GOVERNMENT OF THE DISTRICT OF COLUMBIA
OFFICE OF PLANNING

MEMORANDUM

SUBJECT: Final Report, Zoning Commission Case No.03-12F and 03-13F
Capper/Carrollsborg Venture LLC Hope VI Revitalization Project
- Request for Modification of Approved Order No. 03-12 C / 03-13 C for a 2nd Stage
(Phase 2) Planned Unit Development at Square 769 Lots 18, 20 & 21, 250 M Street, SE

DATE: May 16, 2008

A2.01C

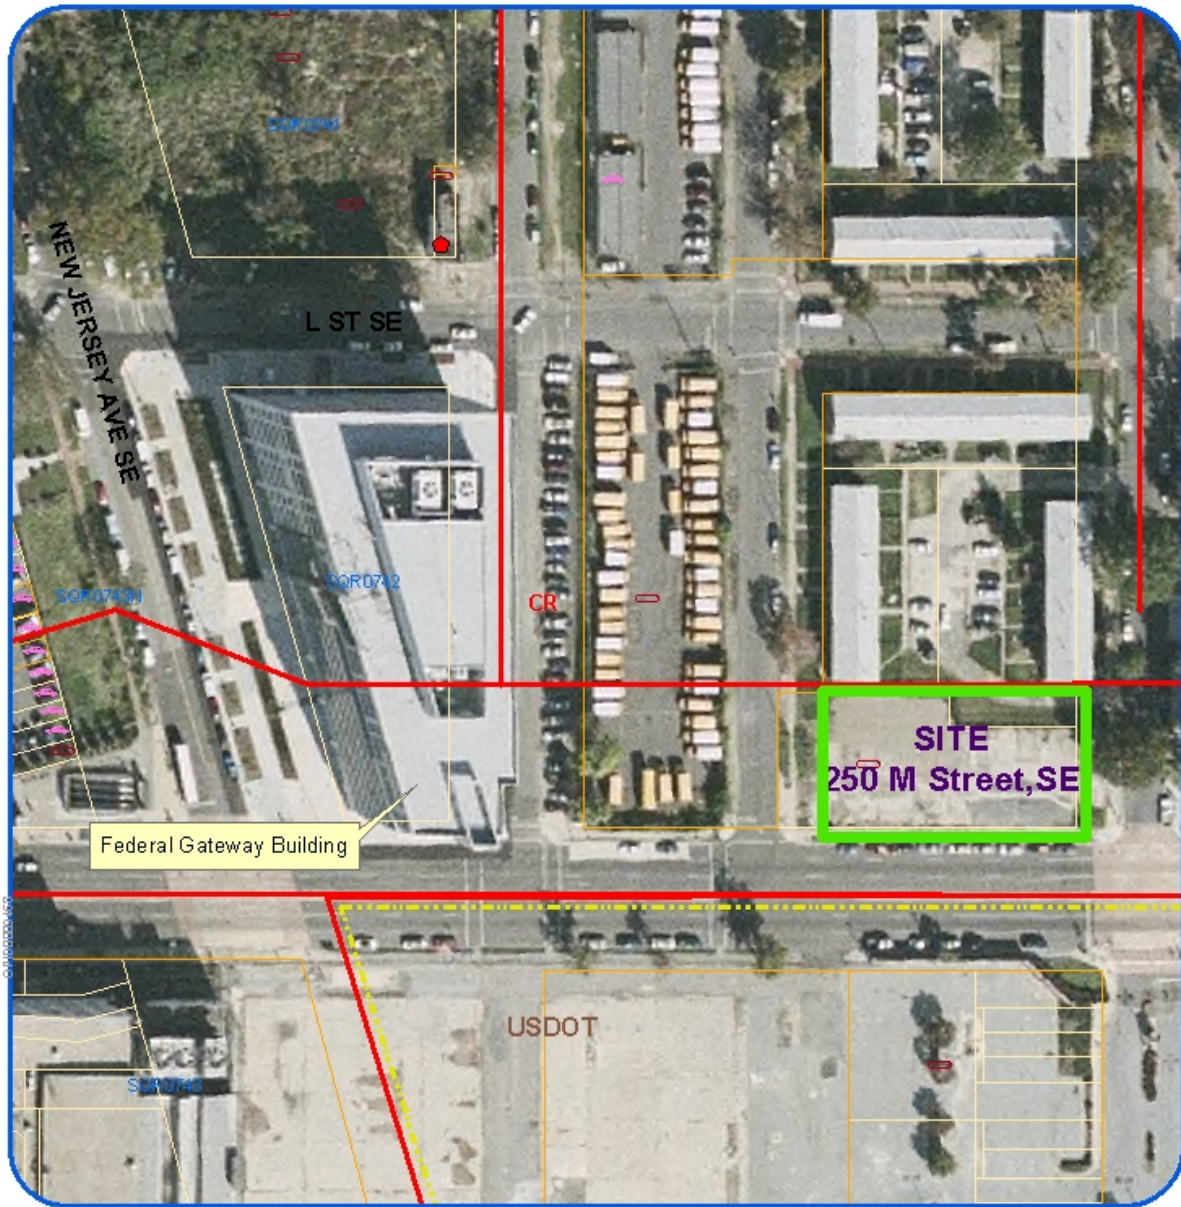
The applicant has provided these height and setback clarifications, which are discussed in Section II.D of this report. However, to give further assurances that the penthouse mechanical structure will not be used for occupation, the Office of Planning (OP) has asked to applicant to replace with one simple door, the two sets of double doors and decorative gates that open from the eastern end of the penthouse onto the green roof.

- **OP recommends that the Commission approve this application for modification of Order No. 03-12C/03-13C, subject to the changing the design detail from two sets of double doors and decorative grates in the penthouse’s eastern wall to a single door without decorative grates.**
